SOUTH WEBER CITY PLANNING COMMISSION AGENDA

6:35 P.M. Public Hearing and Action on Rezone: Request for property located at approx. 600 E. South Weber Dr. (Parcel 13-020-0056), approx. .85 acres, be rezoned from the Residential Low Zone (RL) to Residential Moderate Zone (RM), by applicant Grandon Brimley.

6:55 P.M. Discussion and Action on Conditional Use Permit: Application for South Weber Soccer Facility located at approx. 128 E. South Weber Dr. (Parcel 13-005-0033), approx. 12.21 acres, by developer Kelly Parke.

Our office has completed a review of the Plat and Improvement Plans for the Smith & Edwards Subdivision and associated South Weber Soccer Facility received on August 19th and 30th, 2016. We recommend approval, subject to the following comments and recommendations being addressed prior to final approval from the City Council.

SITE UTILITY PLAN
SOUTH WEBER SOCCER FACILITY
270 NORTH HIGHWAY 126
SOUTH WEBER, DAVIS, UTAH

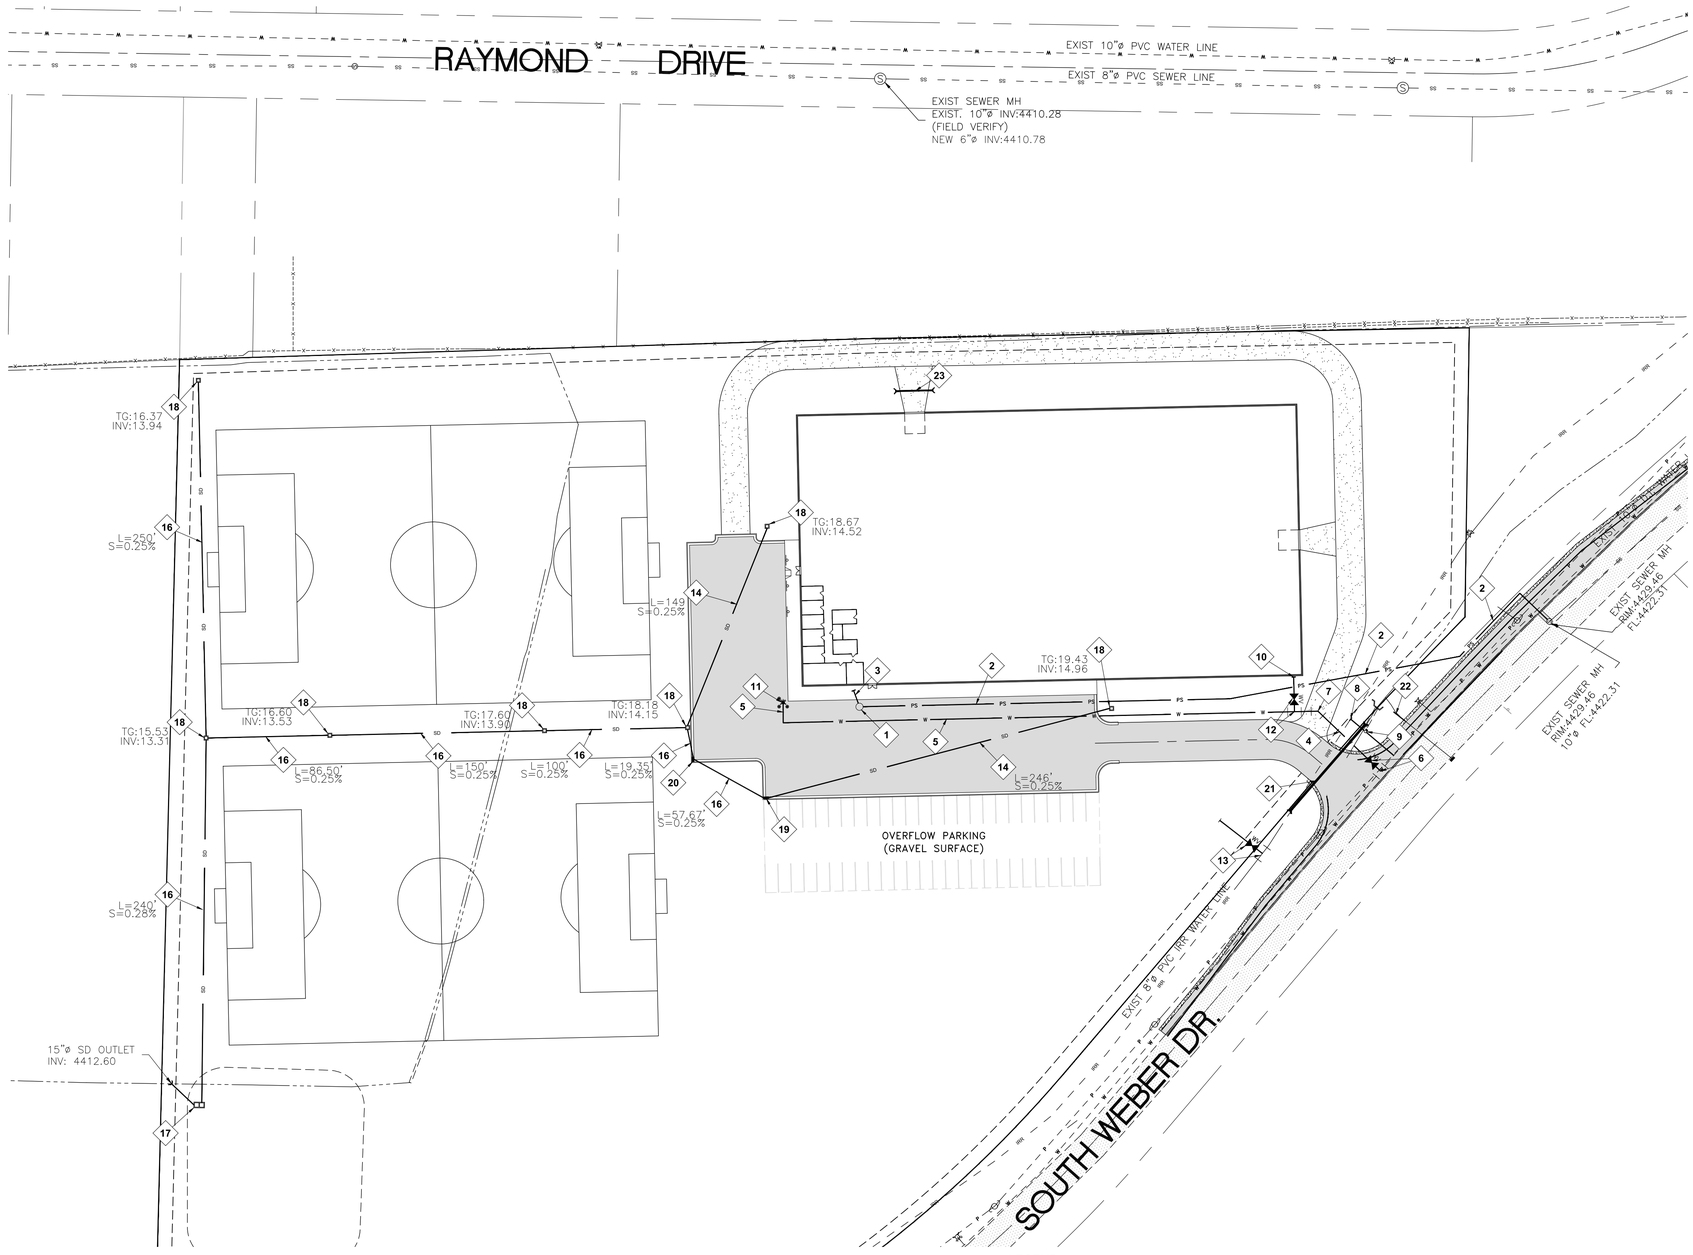
4. Improvement Plans. The following are items related to the improvements.
    a. Sheet #C3. The plans need to show the sewer lateral from the building to wherever it is being proposed (assumed to be in Raymond Drive).
